Re: EB-2020-0065 – Enbridge Gas Inc. – Branchton Relocation Project

EB-2020-0065 – Branchton Relocation Application

Interrogatories of Environmental Defence To Enbridge

Reference: Exhibit C, Tab 2, Schedule 1, Page 12

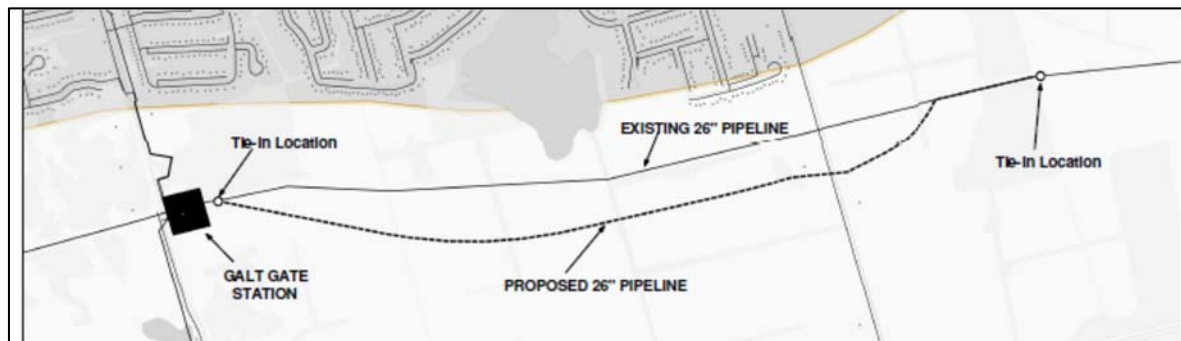
- (a) Does Enbridge undertake to implement all of those recommendation? If not, please explain which ones it will and will not implement and explain why.
